Viyellatex Limited (Extension)

297 khairtul, Tongi, Gazipur.
(23.9198555441, 90.387490388)
7 November 2023

2. Observations

Observation-3: Discrepancies in as-built drawings (Building-3 (HR Building)).

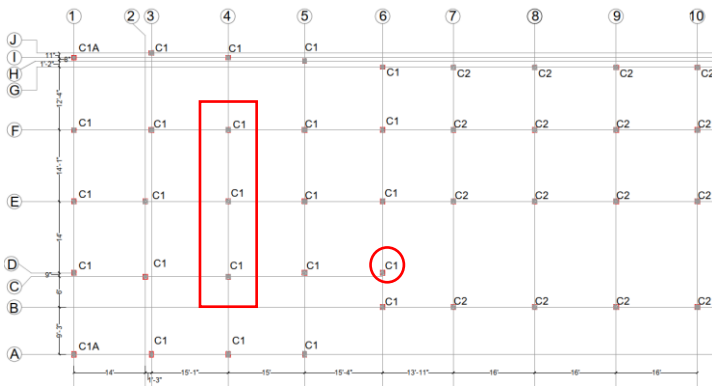
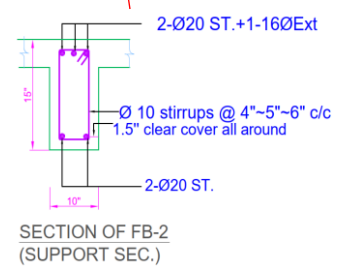
Description: During the inspection, mismatches were found between the onsite condition and the as-built drawing.

- Marked C1 column size was found 250x300 mm instead of 300x300 mm.
- FB2 was found 250x450 mm instead of 250x375 mm.
- Diagonal truss member was found double angle L-50x50x4 instead of single angle.

However, the building engineer is required to survey the full structure and produce accurate as-built drawings.

Observation 5: Crack found on false slab and wall in the toilet area. (Building-3 (HR Building)).

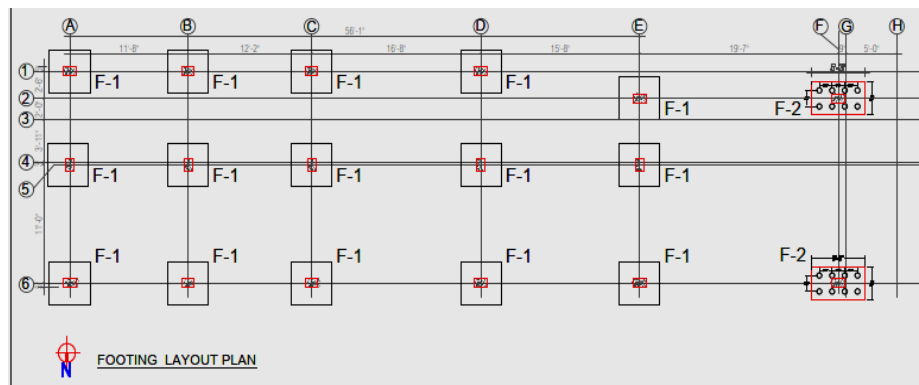
Description: Crack was found on false slab and wall in the toilet area. The building engineer is required to repair the crack as per the suggestion of the building engineer.

Observation-18: Lack of lateral stability (Building-6: Utility-3).

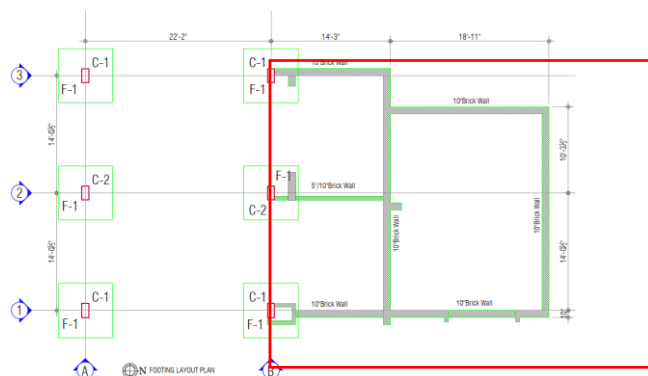
Description: Lateral stability is provided through truss frame action only, but no roof/wall bracing/compression member is provided therefore there is no obvious lateral stability system in this shed. The building engineer is required to check the lateral stability of the shed.

Observation-22: Beam crack observed at ground floor roof beam. (Building 7 (Security Building))

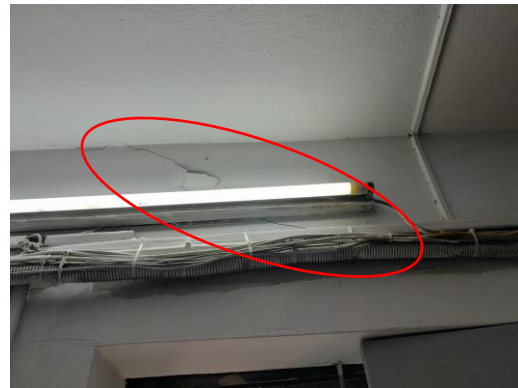
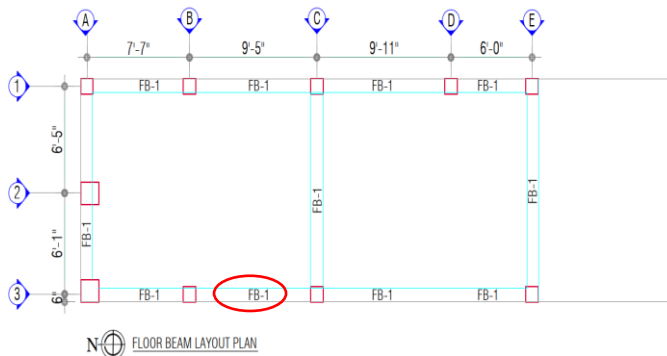
Beam crack observed at ground floor roof beam. (Building 7 (Security Building))	The building engineer is required to produce an investigation report regarding the extent of the crack and provide remedial measures accordingly.	Immediate
	Carry out suggested remedial works where required.	within 6 months
Lack of design report. (Building 9 (Utility-01)).	The building engineer is required to prepare a design report based on in-situ material strength & software-based analysis and submit it to RSC for review.	within 6 weeks
	Carry out suggested remedial works if required.	within 6 months
Discrepancies in as-built drawings. (Building 9 (Utility-01)).	The building engineer is required to survey the full structure and produce accurate as-built drawings.	within 6 weeks
Damage beam & column in the boiler room. (Building 9 (Utility-01))	The building engineer is required to produce an investigation report regarding the extent of damage beam & column and provide remedial measures accordingly.	within 6 weeks

Observation-24: Discrepancies in as-built drawings. (Building 9 (Utility-01)).

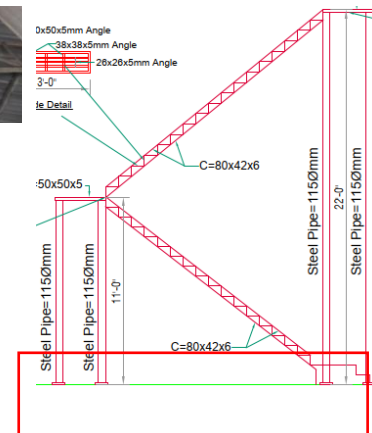
Description: During the inspection, some discrepancies were observed between as built drawing and the on-site condition.

- FB1 was found to be 250x500 instead of 250x375.
- In the truss frame all diagonal members were found single angle 40x40x5 instead of double angle 40x40x5.
- Foundation layout & details were missing for the external steel stair.

Observation 25: Damage beam & column in the boiler room. (Building 9 (Utility-01))

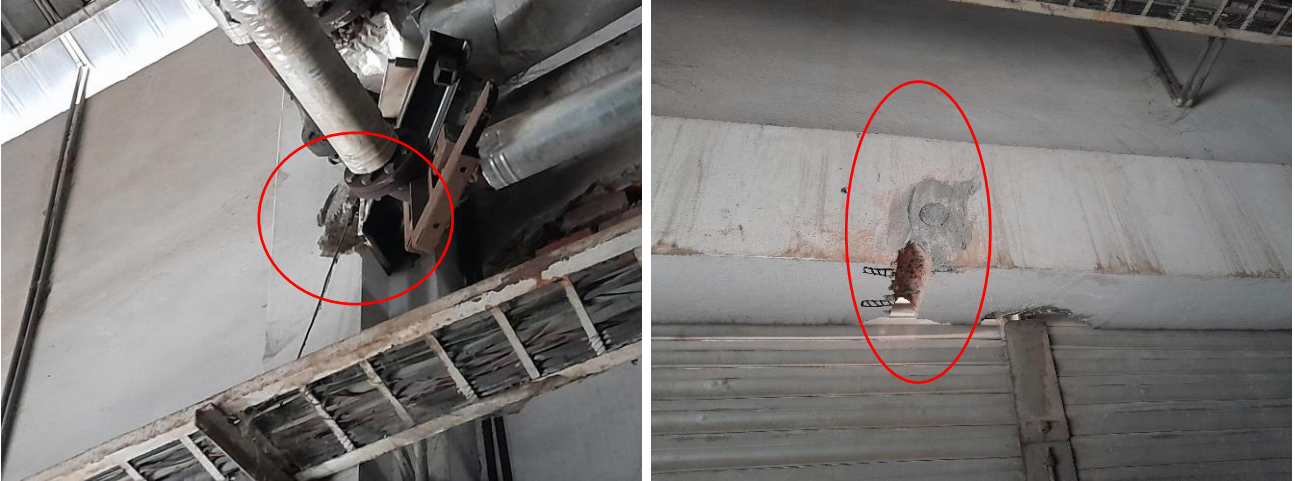
Description: Damage beam & column was observed in the boiler room of building 9. The building engineer is required to produce an investigation report regarding the extent of damage beam & column and provide remedial measures accordingly.

Observation-28: Corrosion on steel members (Shed-4).

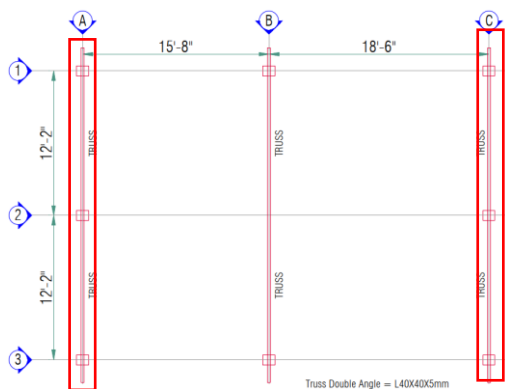
Description: Corrosion was found on steel members. Factory is required to provide rust proof paint on steel members.
